State of New Mexico
Energy, Minerals and Natural Resources

WELL API NO. 30-015-01659
5. Indicate Type of Lease STATE <input type="checkbox"/> FEE <input type="checkbox"/>
6. State Oil & Gas Lease No. 647
7. Lease Name or Unit Agreement Name Empire Abo Unit (309164)
8. Well Number 026A
9. OGRID Numer 873
10. Pool Name or Wildcat Empire; Abo (22040)

SUNDRY NOTICES AND REPORTS ON WELLS

PROPOSED PROCEDURE

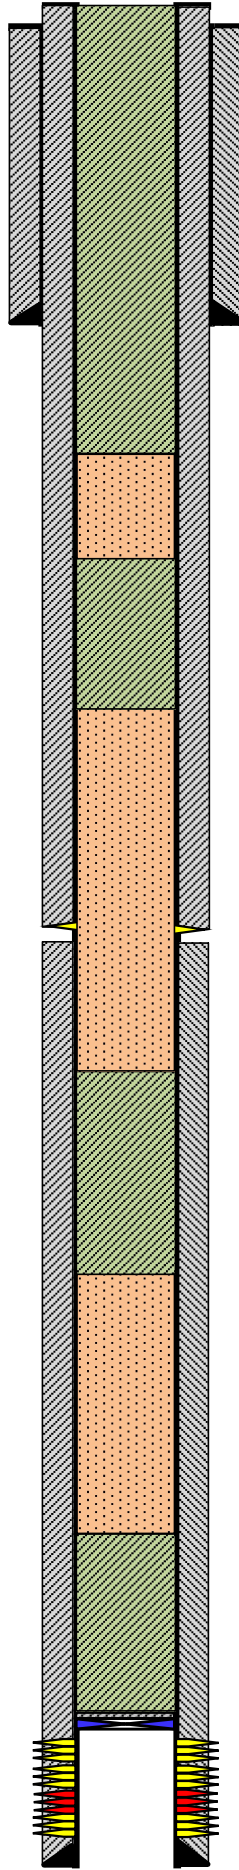
SEE CHANGES TO PROCEDURE

****SEE ATTACHED COA's****
